Riley Purgatory Bluff Creek Watershed District Permit Application Review

Permit No: 2022-077

Project: Dunibar Court Residential Development – The applicant proposes a five-lot single family residential development on a vacant wooded lot.

Reviewer: Katherine Tomaska, EIT, and Scott Sobiech, PE, Barr Engineering

DUNIBAR COURT MINNETONKA, MN HYDROSTOR HS75 STORMWATER CHAMBER SYSTEM

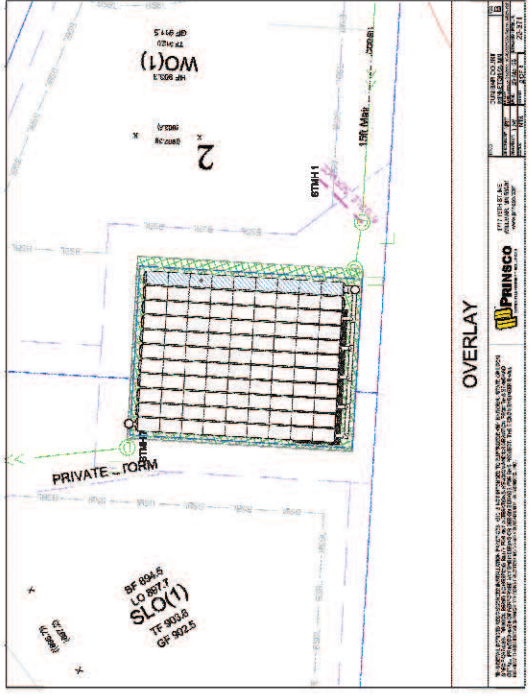
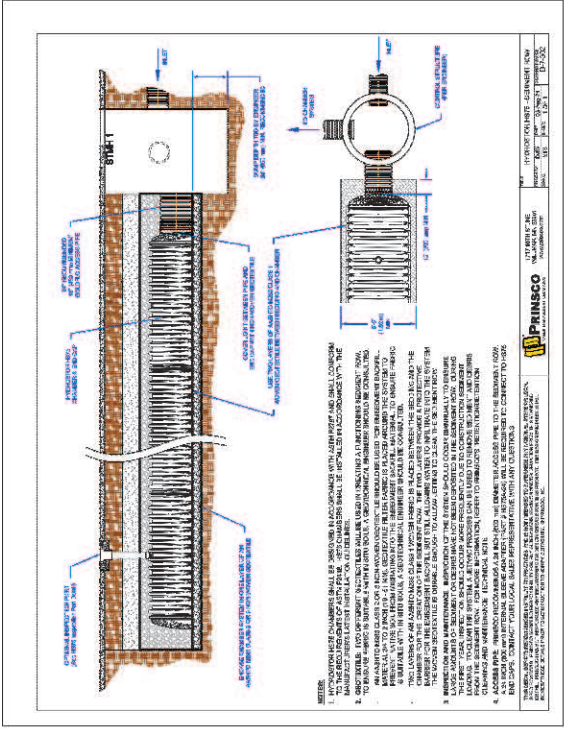
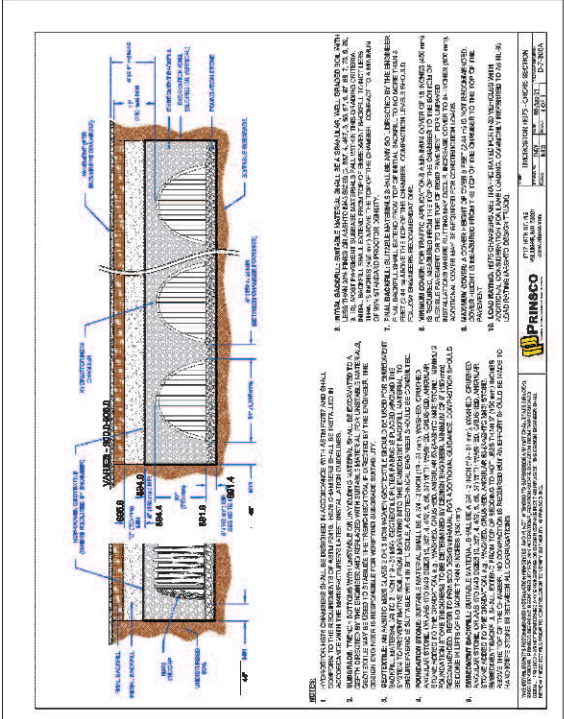
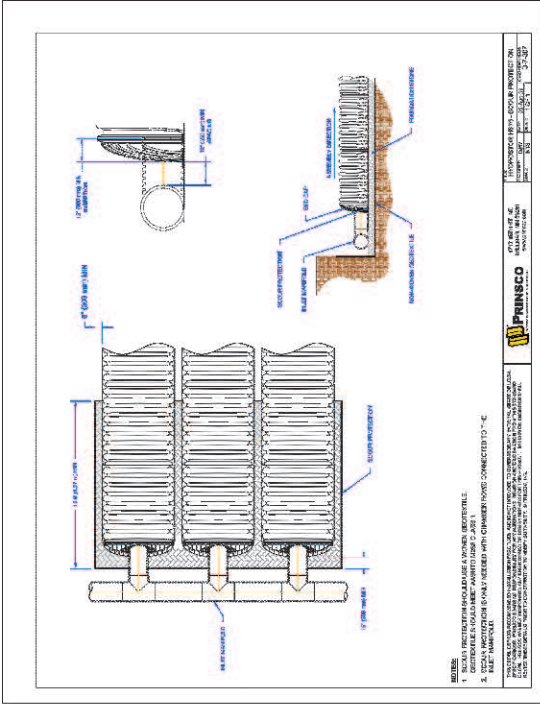
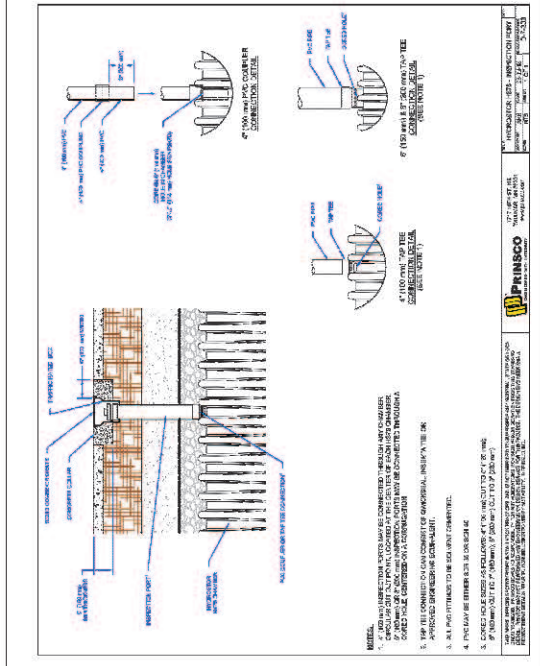
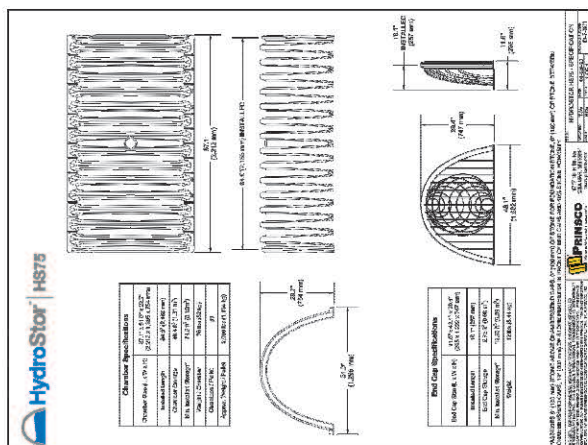
- J1. Supporting information in the form of subsurface investigation and infiltration or hydraulic conductivity testing at the proposed rain gardens and underground stormwater management facility must be provided before the permit is issued. If infiltration capacity is less than needed to conform with the volume abstraction requirement in subsection 3.3a for the proposed rain garden, or there is inadequate separation to groundwater, design modifications to achieve compliance with RPBCWD requirements will need to be submitted in the form of an application for a permit modification or new permit.
- J2. Revise the underground stormwater management facility design to provide for at least 1,069 cubic feet of storage between the bottom of the rock storage layer and the primary outlet elevation (e.g, increase the rock layer to eight inches).

5. Receipt of updated drawings showing design revision so the underground stormwater management facility provides at least 1,069 cubic feet of storage between the bottom of the rock storage layer and the primary outlet elevation (e.g, increase the rock storage layer from six to eight inches).
